S. Canadian WWTP Expansion  
Cost Breakdown

Project No. ST-0138 Date 2/14/2023

Description of Work 60" Concrete Cap of FRP Line at Outfall Structure

<b>Subject:</b>	Disinfection Facility Fire Line Material		
<b>Date:</b>	9/19/2023	<b>Status:</b>	New
<b>Priority:</b>	Normal	<b>Reason:</b>	Alternate Proposal
<b>Discipline:</b>	Plumbing	<b>Reference:</b>	Please see the attached plan sheet M-550 and email correspondence with the Chief Plumbing Inspector, Geary McMillon.

SHEET  
M-550

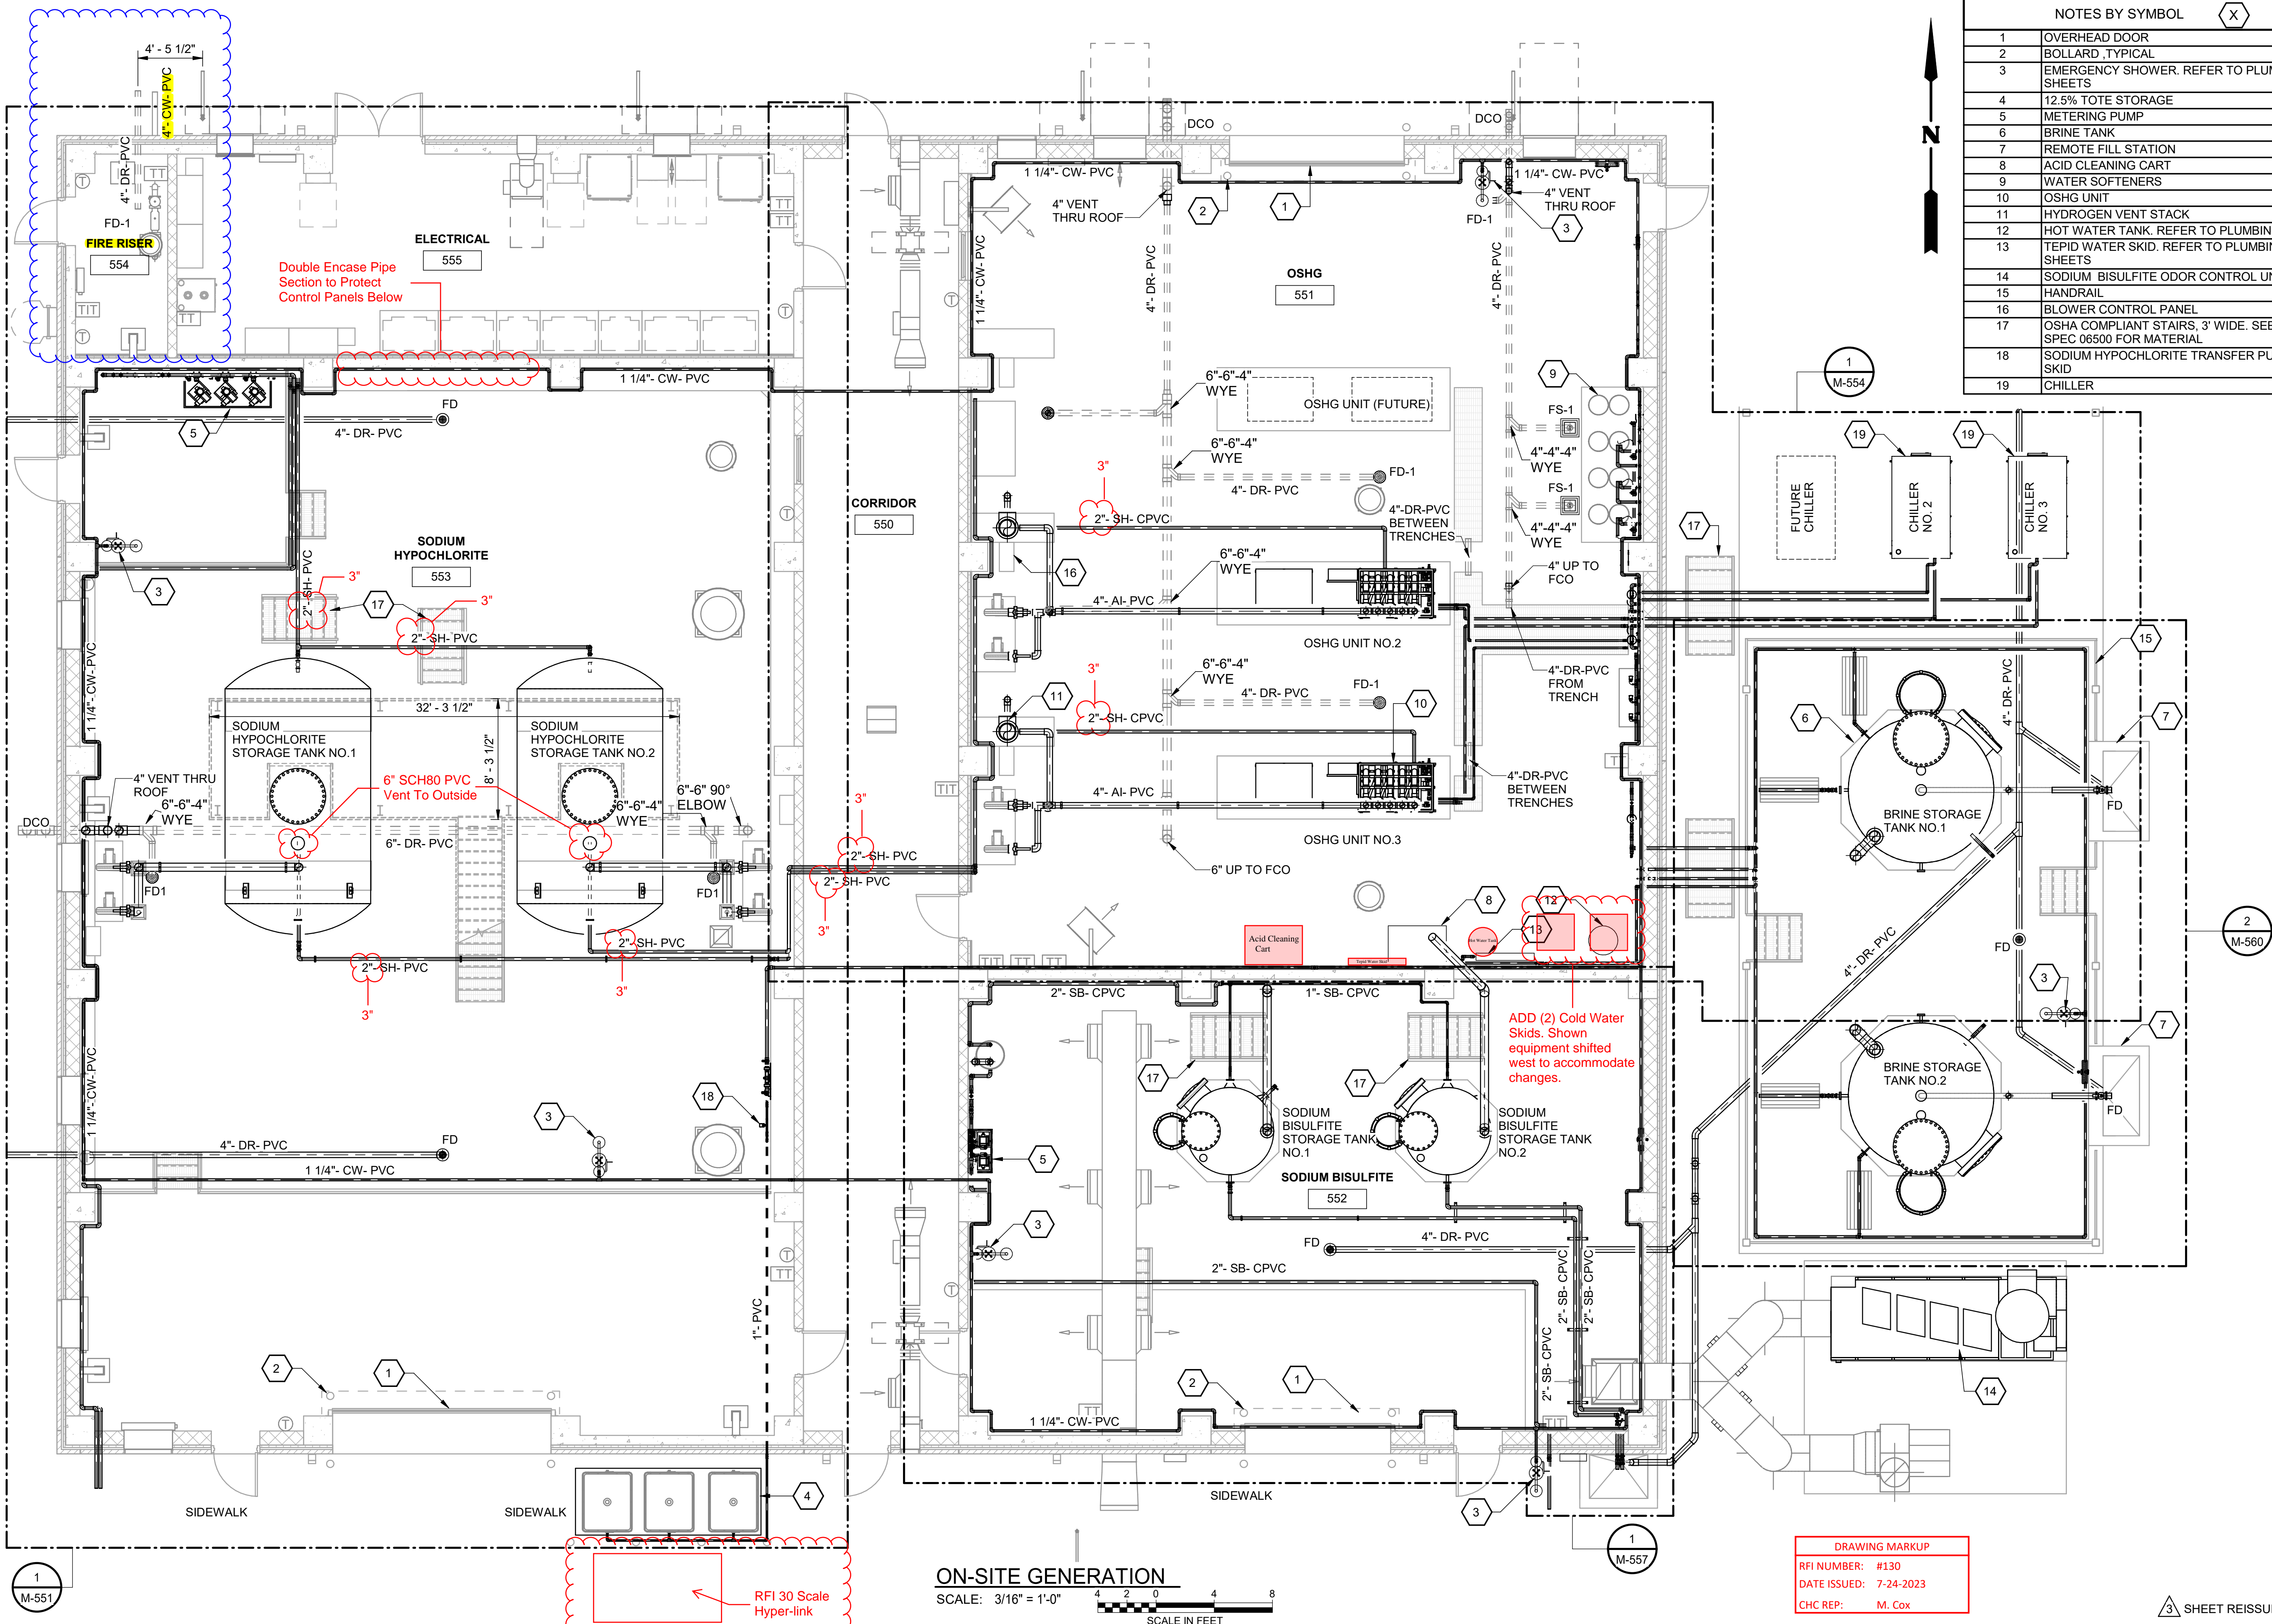
Sheet M-550 identifies the fire riser material coming into the building to be "PVC." This piping is 4" and therefore is C-900 PVC per the pipe schedule.

Per the Authority Having Jurisdiction, the City of Oklahoma City, PVC is not acceptable as fire line material under building slabs and does not comply with International Plumbing Code 2015, the current edition in use by the AHJ.

Per emails with City of Oklahoma City Chief Plumbing Inspector Geary McMillon, material to be Ductile Iron Pipe under slab. It is allowable to transition to C-900 for the yard piping not under any structure. Please advise if this is an acceptable solution.

This is an acceptable solution.
